OHIO TURNPIKE AND
INFRASTRUCTURE COMMISSION

ADDENDUM NO. 3

CONTRACT NO. 39-14-02

RIGHT TWO (2) LANES AND SHOULDER RECONSTRUCTION
MILEPOST 159.80 TO MILEPOST 164.82
CUYAHOGA COUNTY, OHIO

| CONTRACT 39-14-02 SHEET 11 OF 414 | | | |

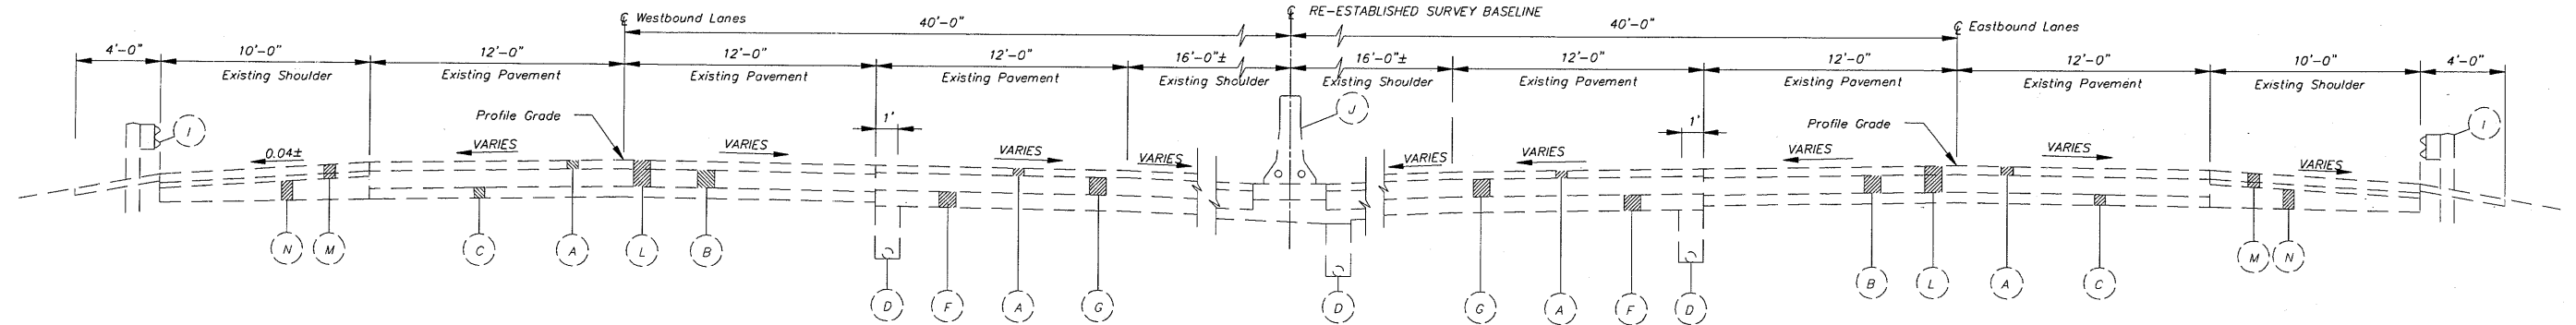
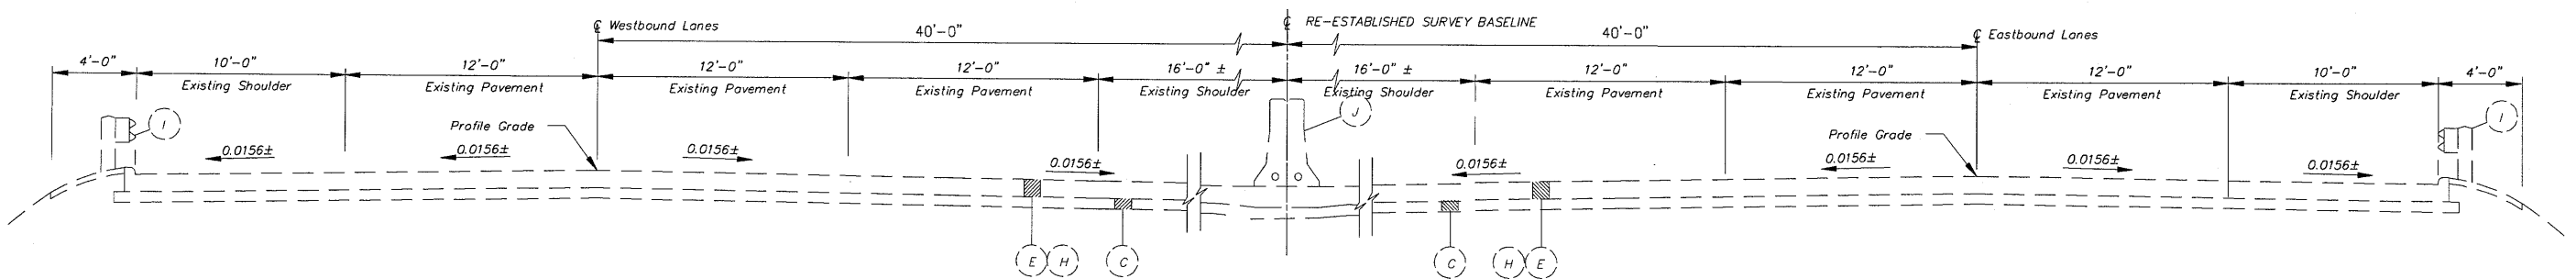
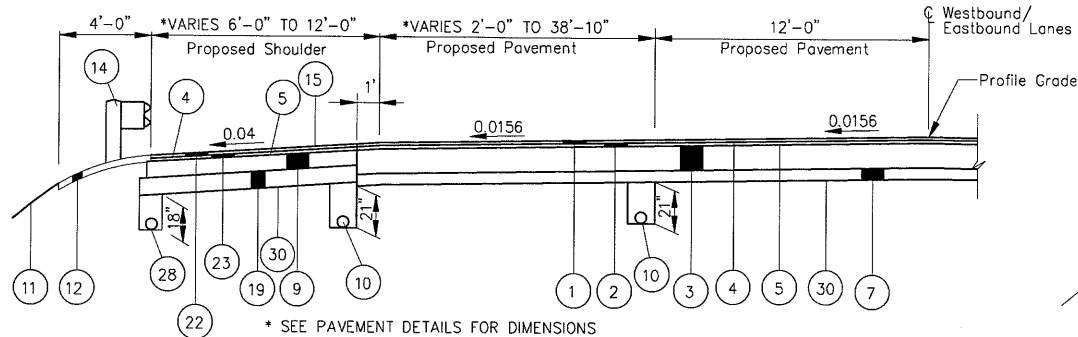
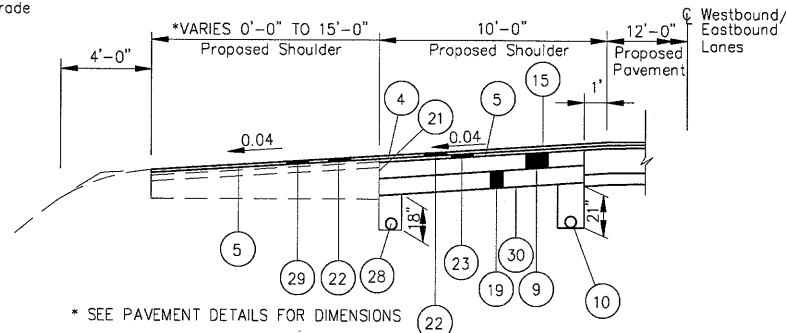
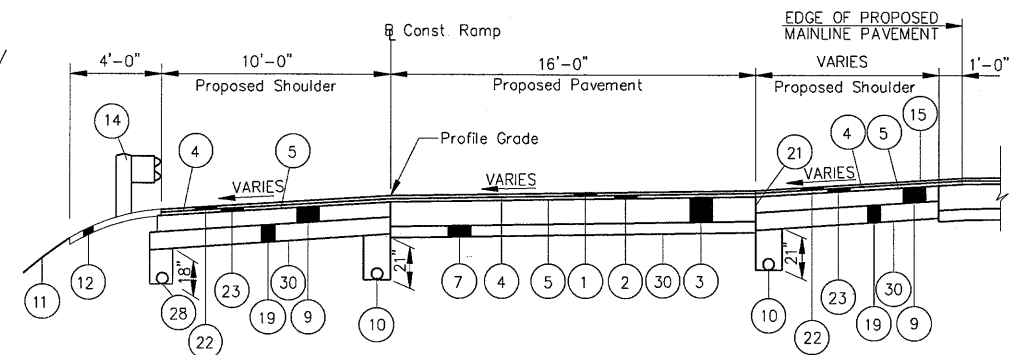
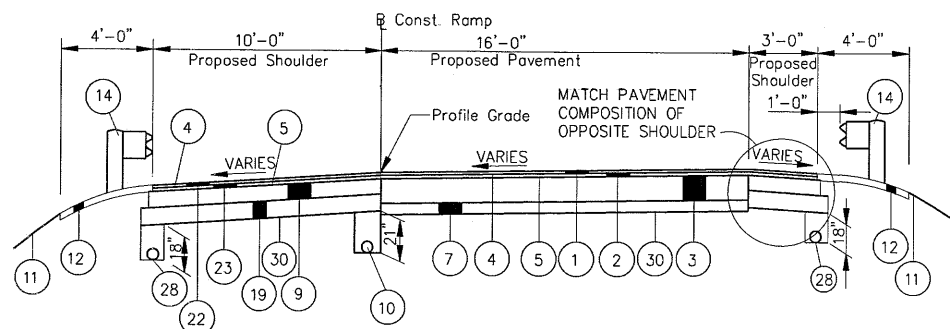
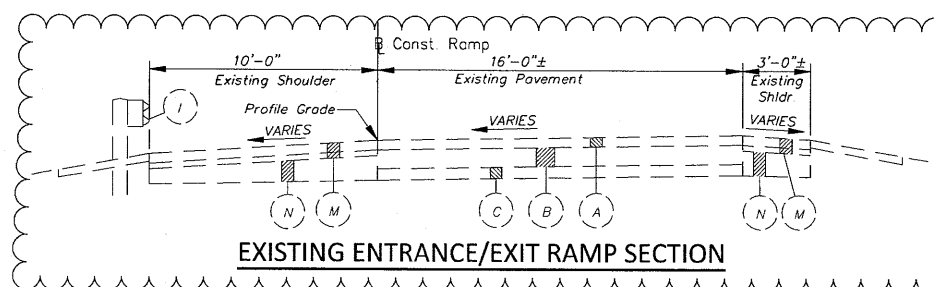
A new Typical Section detail entitled "**Existing Entrance/Exit Ramp Section**" is added via this Addendum No. 3.

| CONTRACT 39-14-02 SHEET 47 OF 414 | | | |

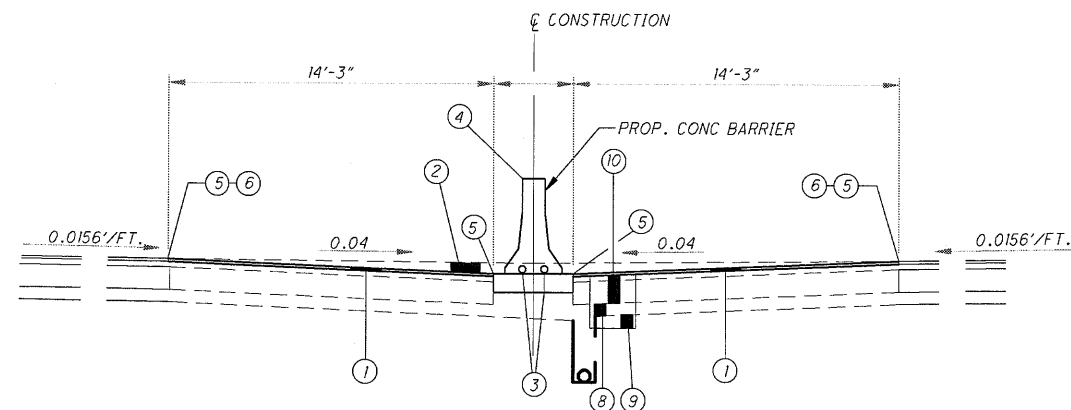
A new "**Crossover Restoration Typical Section**" detail is added via this Addendum No. 3 to Sheet 47 of 414.

A#13 Yes, the temporary slotted drains are to be removed during MOT Phase 4 and the cost is included in the Unit Price Bid of for Item 615 – Pavement for Maintaining Traffic, Class A, As Per Plan. A new typical section is added via this Addendum No. 3 to Sheet 47 of 414.

A#14 Restoring the crossovers back to the existing condition is included in Item 615 - Pavement for Maintaining Traffic, Class A, As Per Plan. A new typical section showing the pavement build-up is added via this Addendum No. 3 to Sheet 47 of 414.

| CONTRACT 39-14-02 SHEET 88 OF 414 | | | |

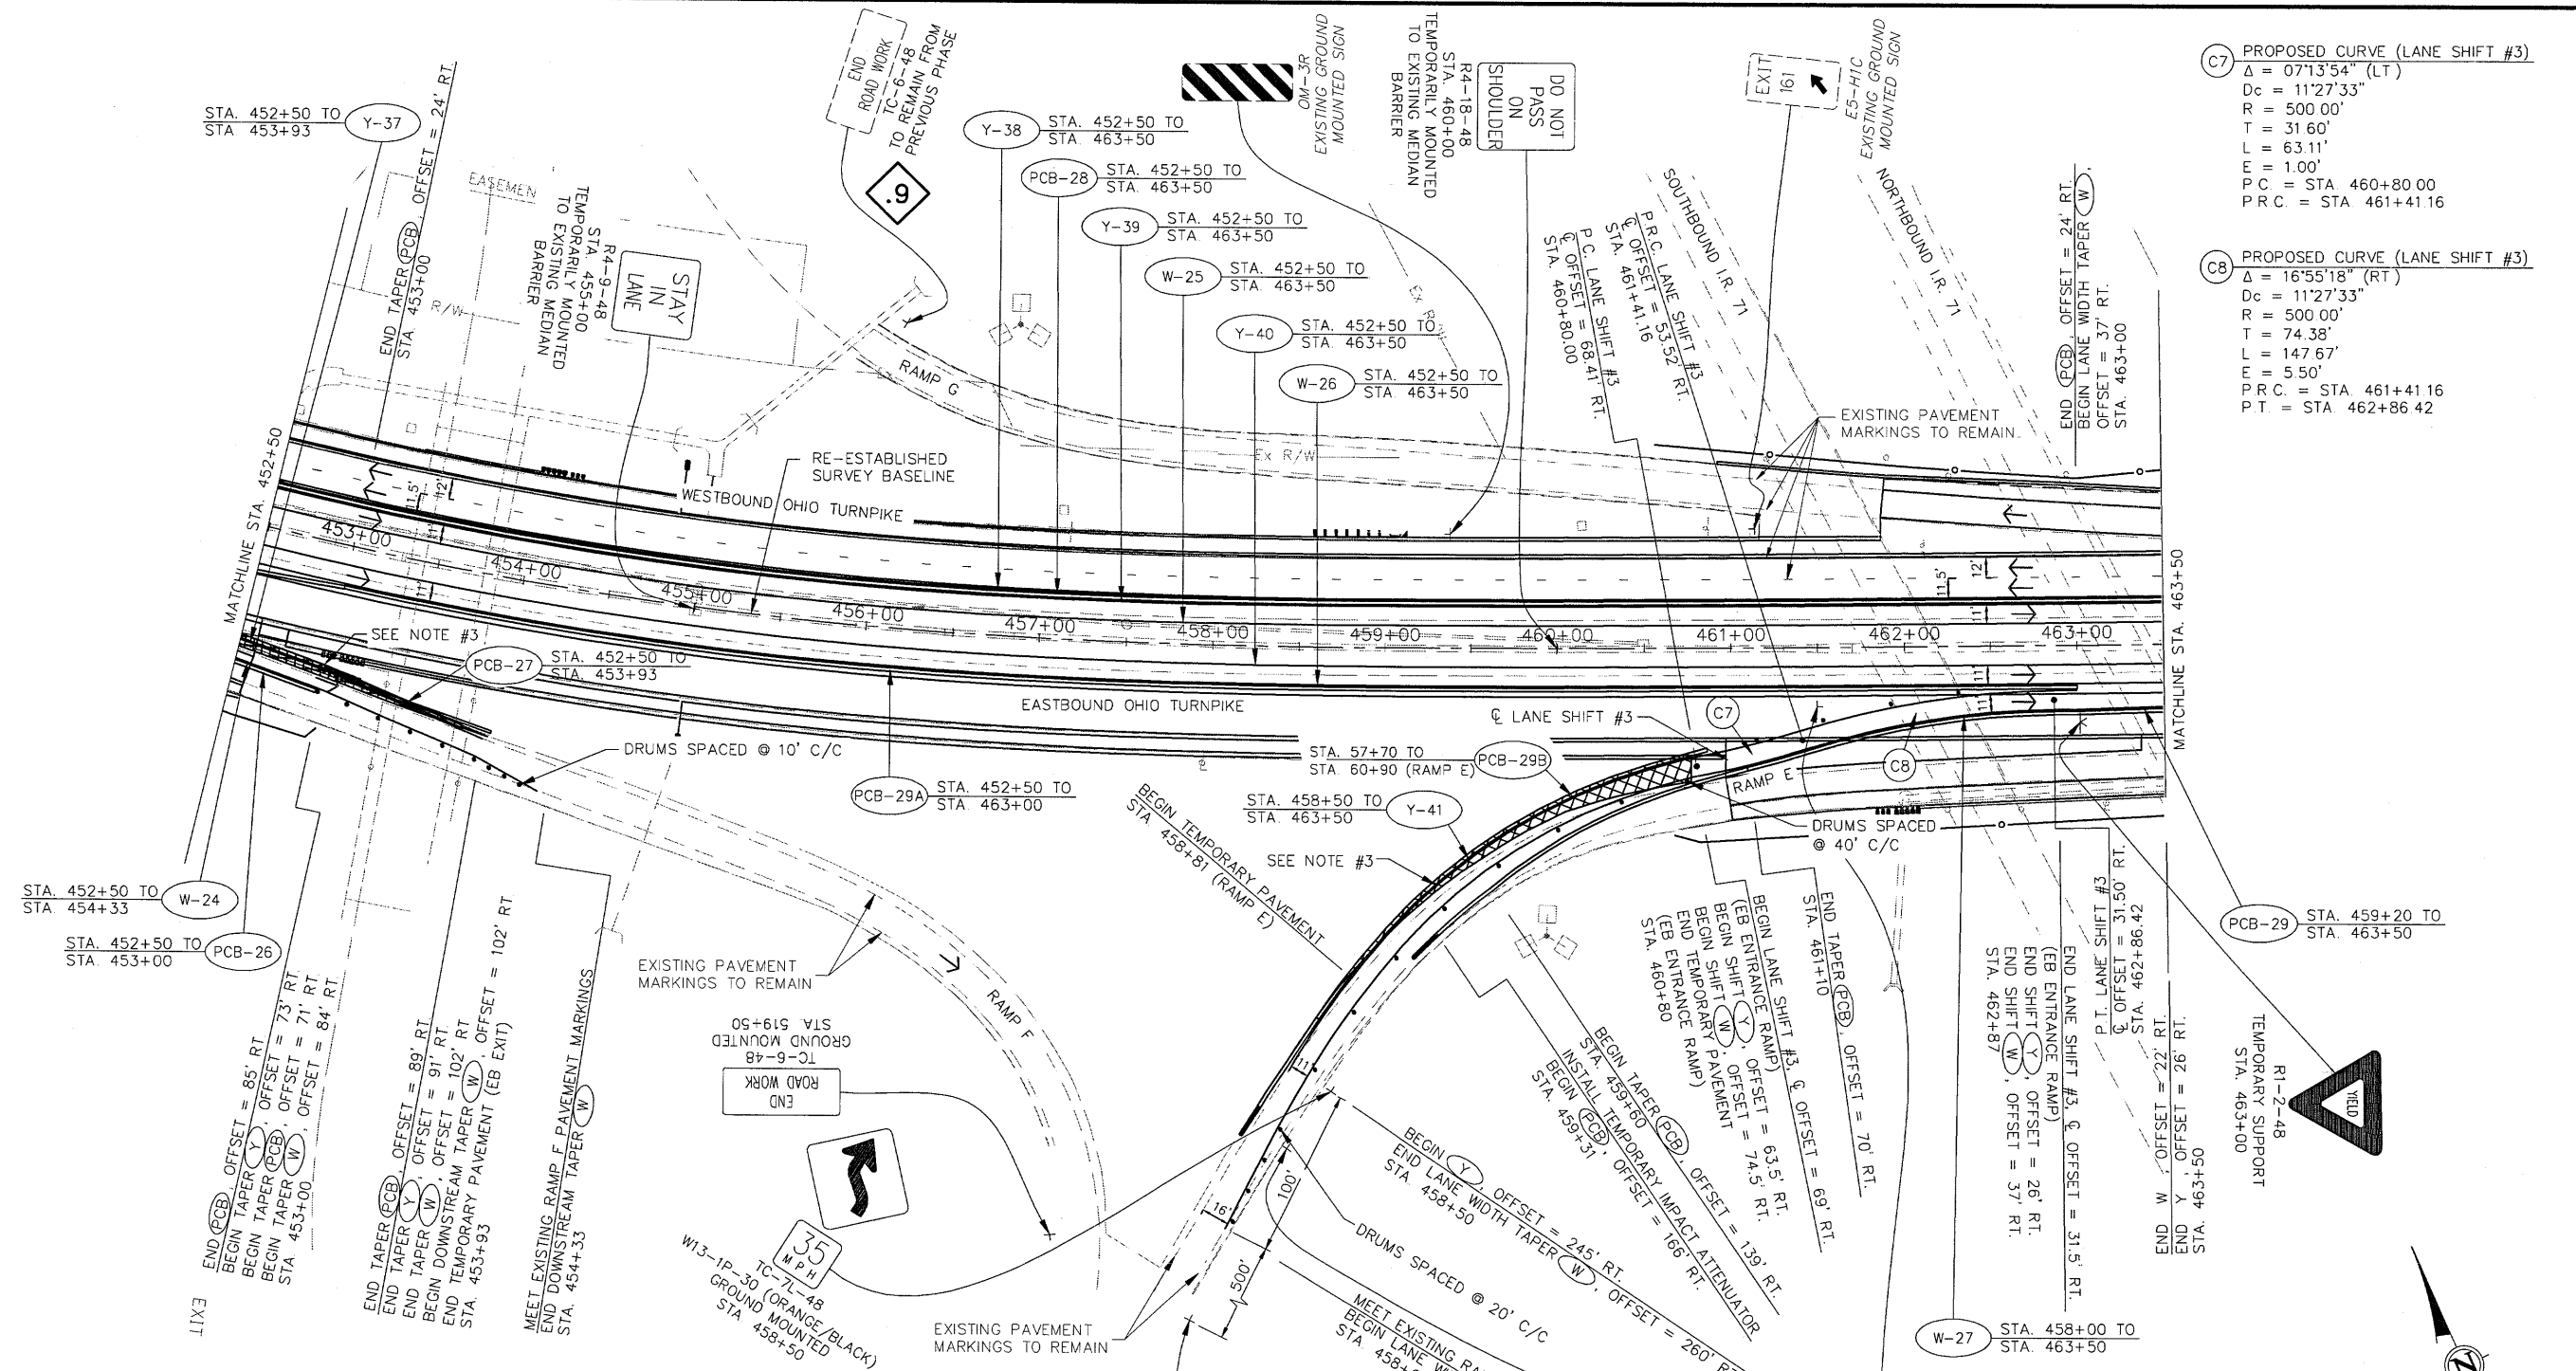
Plan Sheet 88 of 414

General Note 3 is modified via this Addendum No. 3 as follows:

- "3. TEMPORARY PAVEMENT SHALL BE PAID FOR UNDER ITEM 615 –PAVEMENT FOR MAINTAINING TRAFFIC, CLASS A. TEMPORARY EMBANKMENT SHALL BE PAID FOR UNDER ITEM 615 – ROADS **PAVEMENT** FOR MAINTAINING TRAFFIC, CLASS A, AS PER PLAN."

| CONTRACT 39-14-02 SHEET 114 OF 414 | | | |

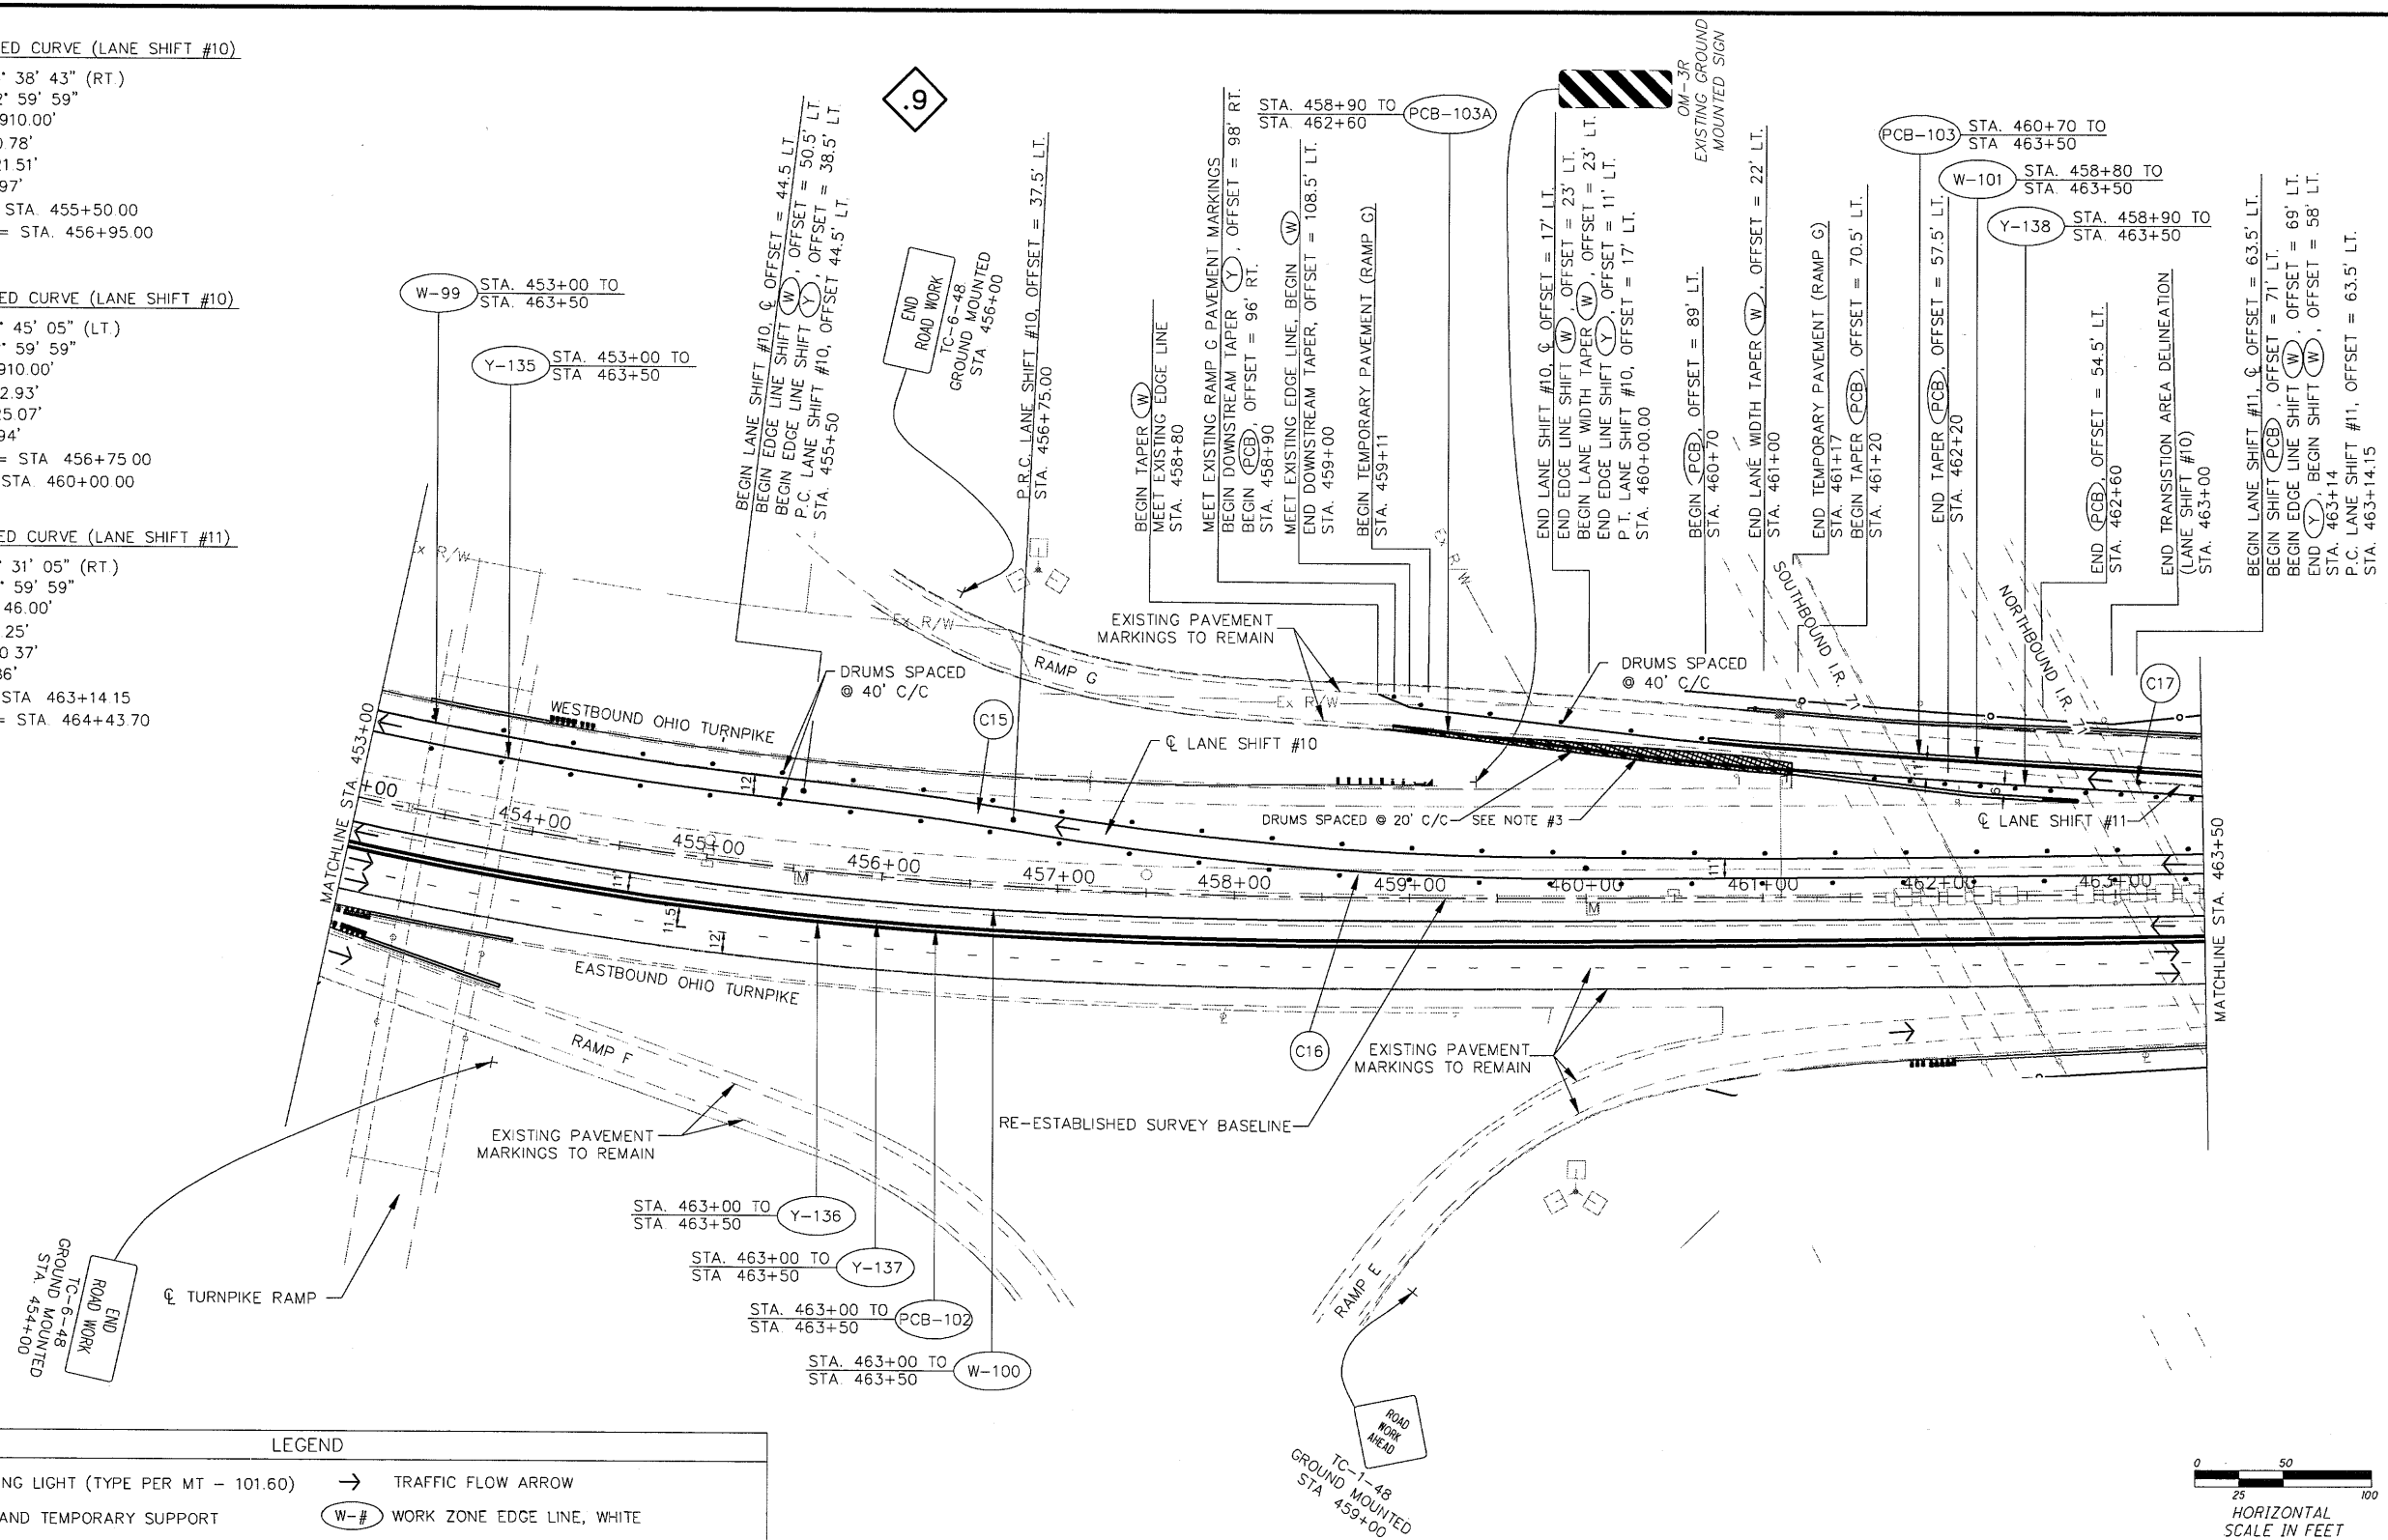
Plan Sheet 114 of 414

General Note 3 is modified via this Addendum No. 3 as follows:

- "3. TEMPORARY PAVEMENT SHALL BE PAID FOR UNDER ITEM 615 –PAVEMENT FOR MAINTAINING TRAFFIC, CLASS A. TEMPORARY EMBANKMENT SHALL BE PAID FOR UNDER ITEM 615 – ROADS **PAVEMENT** FOR MAINTAINING TRAFFIC, CLASS A, AS PER PLAN."
